ATTACHMENT 2 TO AEP:NRC:0896H
REVISED PAGES FOR THE
DONALD C. COOK NUCLEAR PLANT UNITS 1 AND 2
TECHNICAL SPECIFICATIONS

ATTACHMENT 3 TO AEP:NRC:0896G
FLOW DIAGRAM OF DIESEL FUEL OIL TANKS
AND EXPLANATION OF WHY EMPTYING TANKS
REQUIRES DUAL UNIT SHUTDOWN

Figure 3

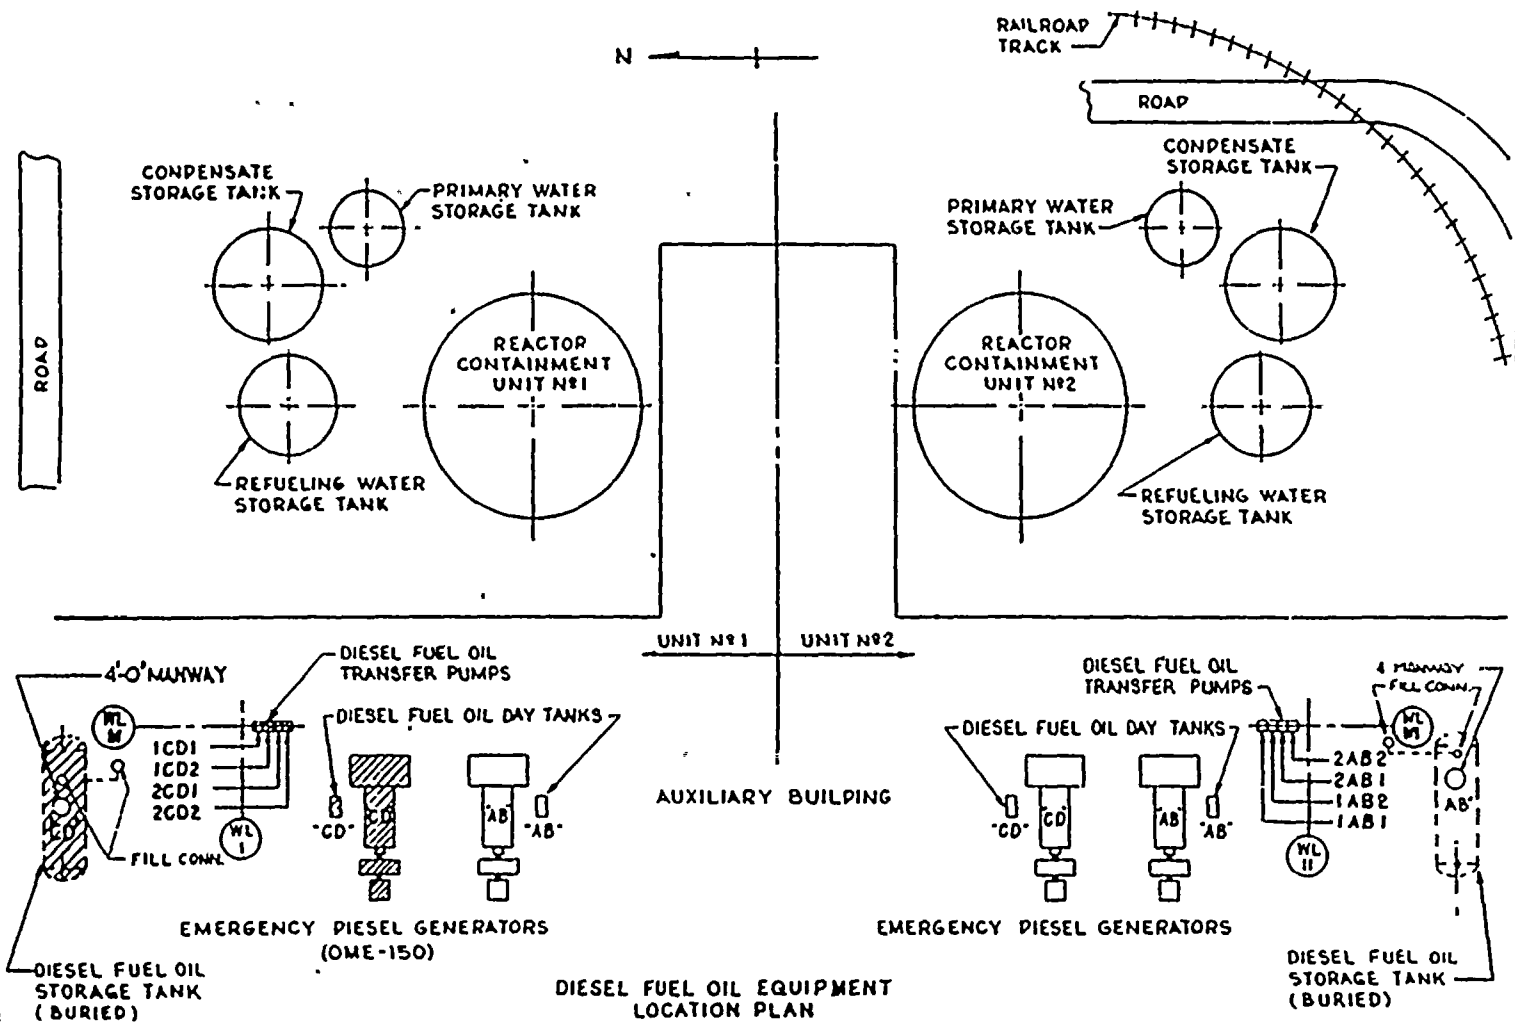
As shown on Figures 1 and 2, the "AB" tank supplies fuel to the Unit 1 "AB" diesel generator and the Unit 2 "AB" diesel generator, while the "CD" tank supplies fuel to the Unit 1 "CD" diesel generator and the Unit 2 "CD" diesel generator. Figure 3 shows the location of the tanks relative to each other. There is no cross-tie between the tanks; therefore, to empty either tank to clean it would require making a diesel generator in each unit inoperable. Since cleaning the tanks cannot be accomplished within the 72-hour Action Statement of T/S 3.8.1.1, emptying the tanks to clean them would require both units to be shut down.
